NOTES: (UNLESS OTHERWISE SPECIFIED)		PARTS LIST	
1. DO NOT SCALE FROM DRAWING.		DIMENSIONS ARE IN MILLIMETERS	
2. REMOVE ALL SHARP EDGES, R5 MIN.		TOLERANCES: X $\pm$ 0.1 XX $\pm$ 0.05 ANGULAR $\pm$ 0.2°	
		MATERIAL: 6082-T6 Al	
		FINISH: -- $\mu$ inch	
		DRAWN: R.JONES	
		CHECKED: M.P.LLOYD	
		APPROVED: JAN08	
		SCALE: 1:1	
		PROJECTION:	
		SHEET 1 OF 1	
		CALIFORNIA INSTITUTE OF TECHNOLOGY MASSACHUSETTS INSTITUTE OF TECHNOLOGY IGR, GLASGOW UNIVERSITY GEO 600 GROUP	
		SYSTEM: ADVANCED LIGO	
		SUB-SYSTEM: SUS	
		NEXT ASSY: CO2 Laser Machine	
		PART NAME: Mounting Bracket	
		SIZE: C	
		DWG. NO.: D080041	
		REV.: v2

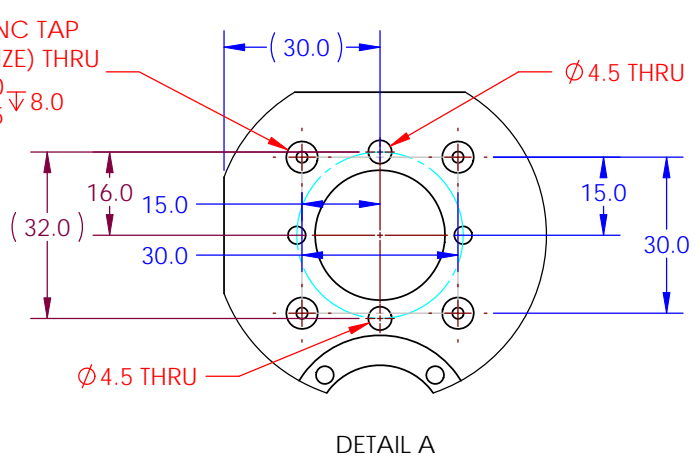
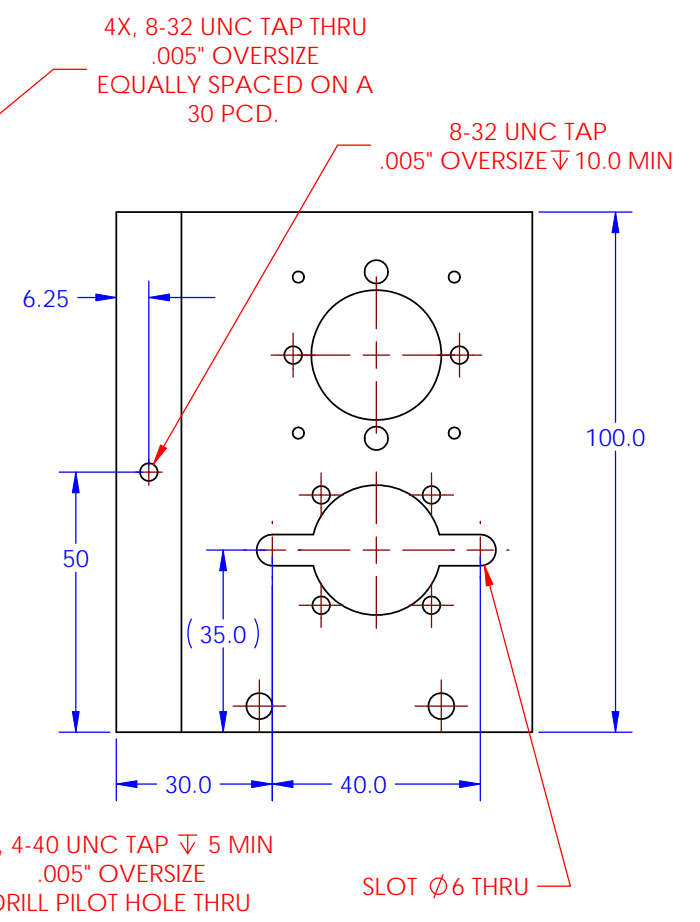
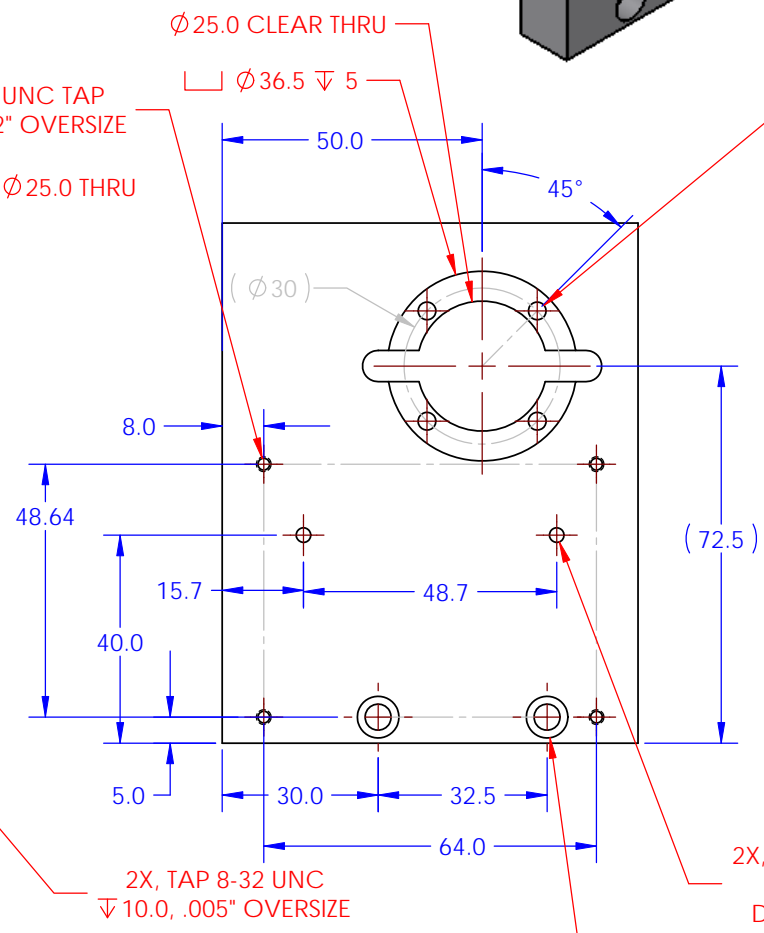
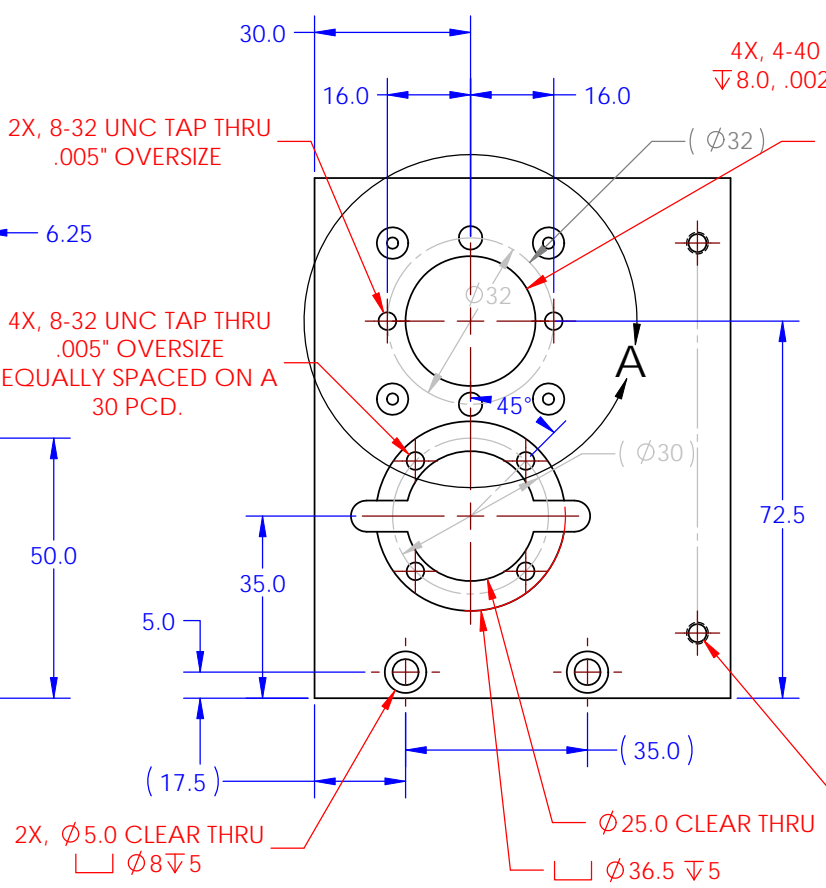
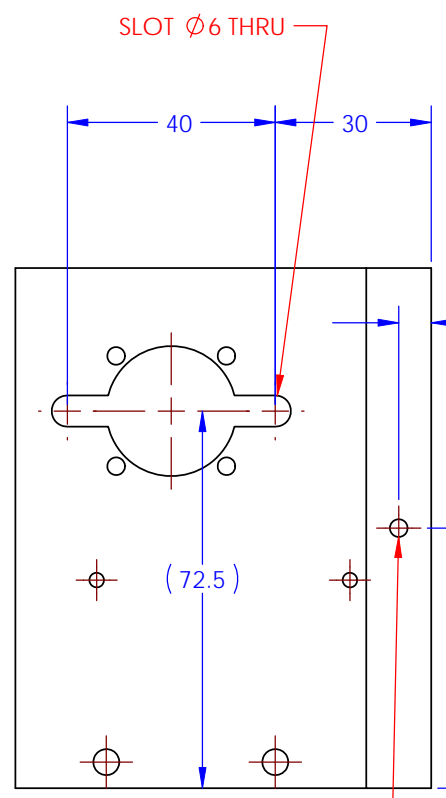
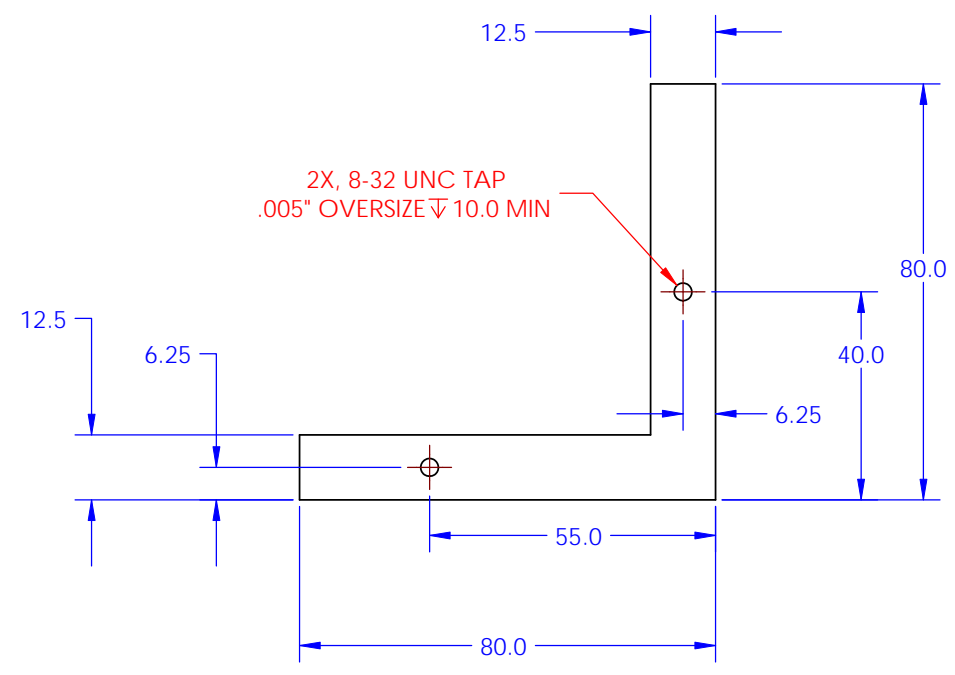
REV.	DATE	DCN #	DRAWING TREE #
00	SEPT07	INITIAL RELEASE (R.JONES)	
01	MAY08	RE-MACHINING DESCRIBED BY "DETAIL A" (R.JONES)
